Doc. No.: HUS-CPB-AR-LTR-00107

Subject: Response to FFAW's Comments on Husky's Environmental Assessment (EA) Review for 2013

Proposed Glenwood Site Survey Extents - 2013

Figure 1

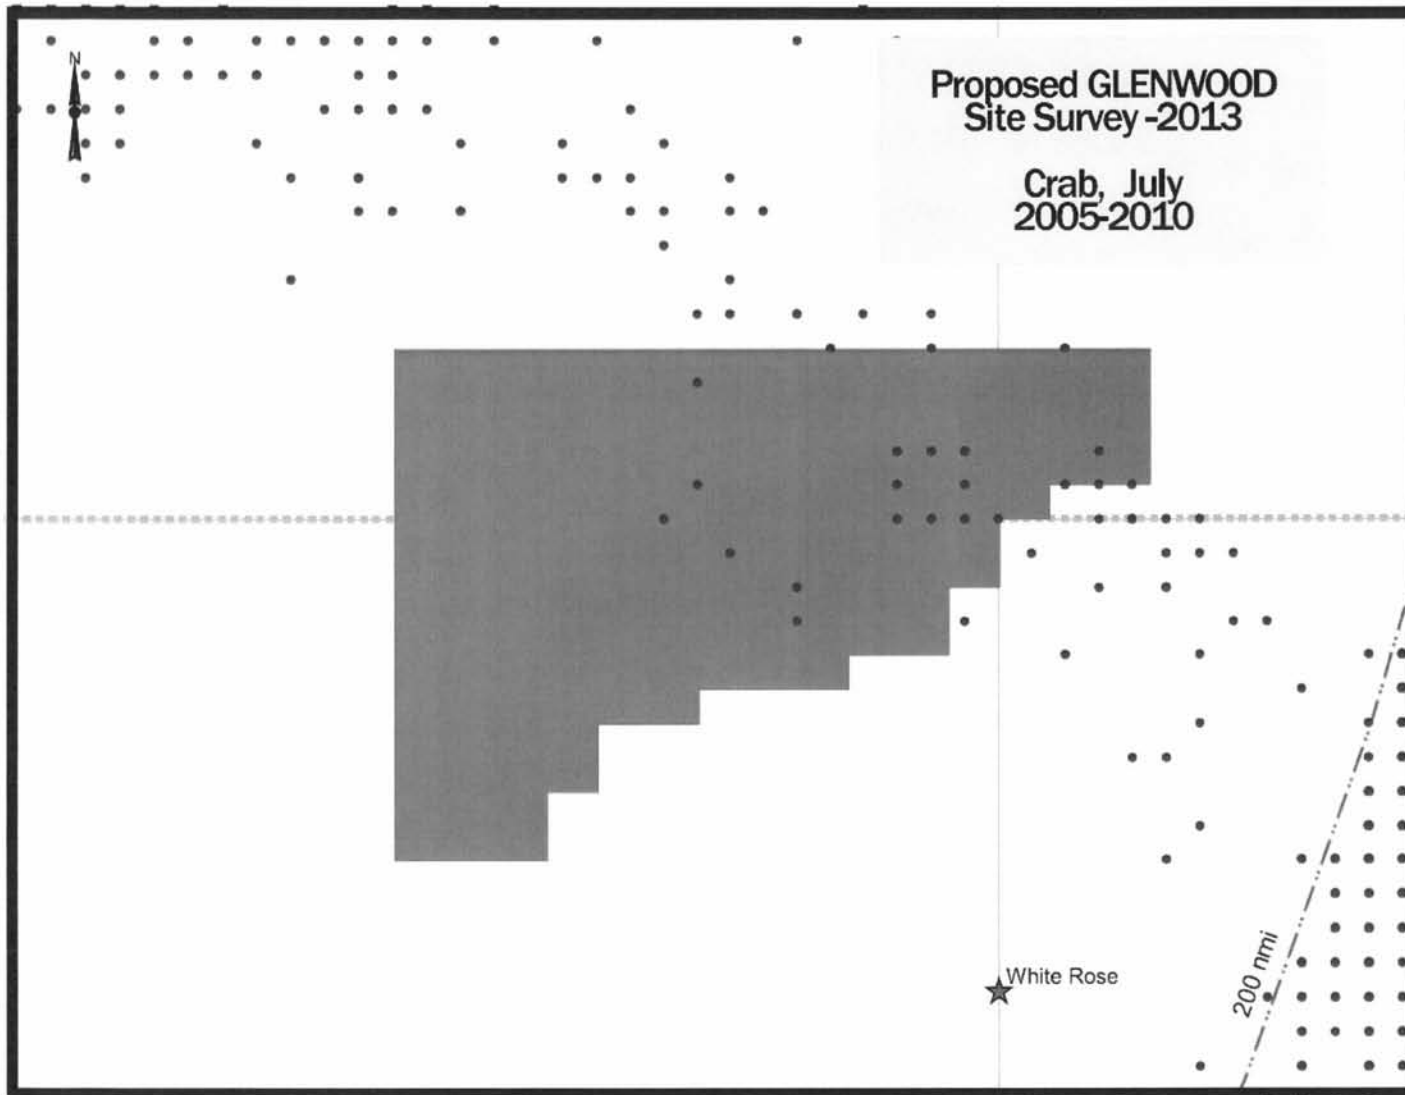
As outlined in the Husky Energy EA Review for 2013 (May 8th, 2013), our current plans are to conduct a wellsite survey within EL 1090R, to the north of the White Rose field. In particular, the wellsite survey is planned to be conducted during July within the green area outlined in Figure 1.
